Product Change Notification

Change Notification #: 113467 - 00
Change Title: Intel® Server System R1208JP4OC
PCN 113467-00, Product Design
Add a Mylar and a Plastic Block, Add an
ODD (Optical Disc Drive) Accessory Kit

Date of Publication: November 25, 2014

Figure-1

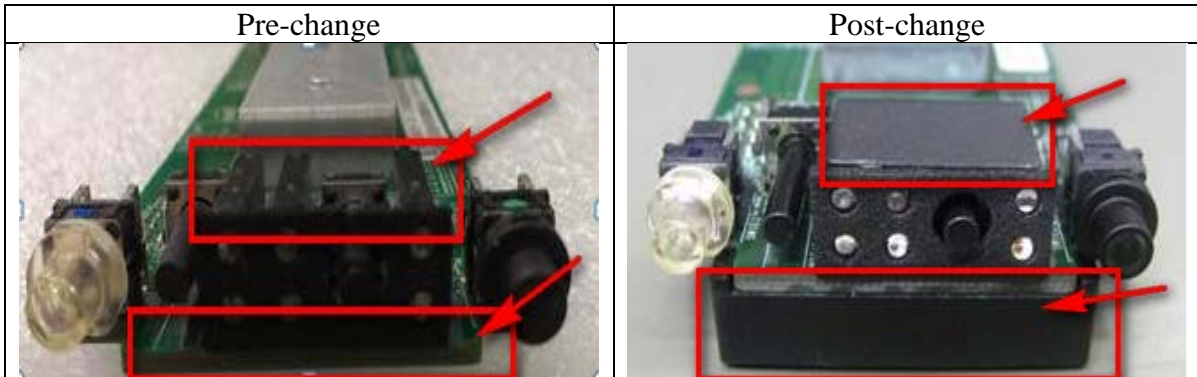
1. Add a mylar on the top of the front panel board and add a plastic block for the front end under the front panel board to hold parts more securely. See Figure-1 as below:

Figure-2: ODD Accessory Kit

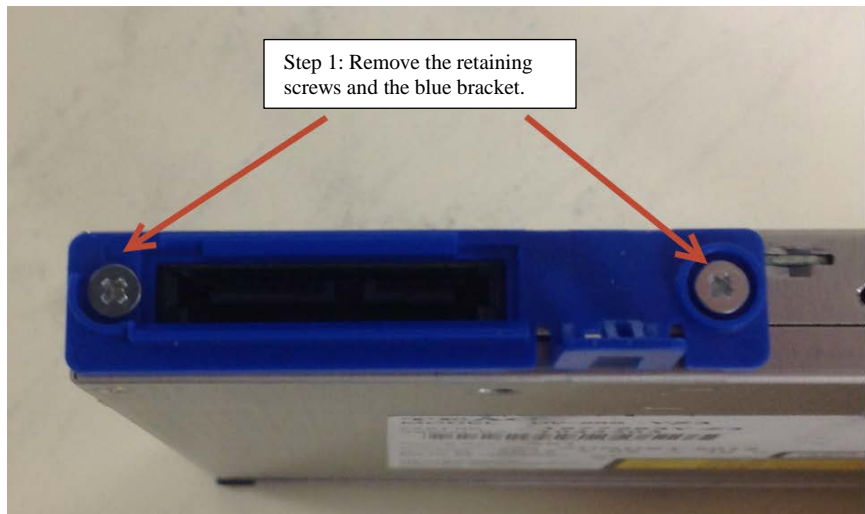
2. Add an ODD accessory kit. See Figure-2 as below:

Customers can follow the two steps below to install the shim on the optical disc drive.
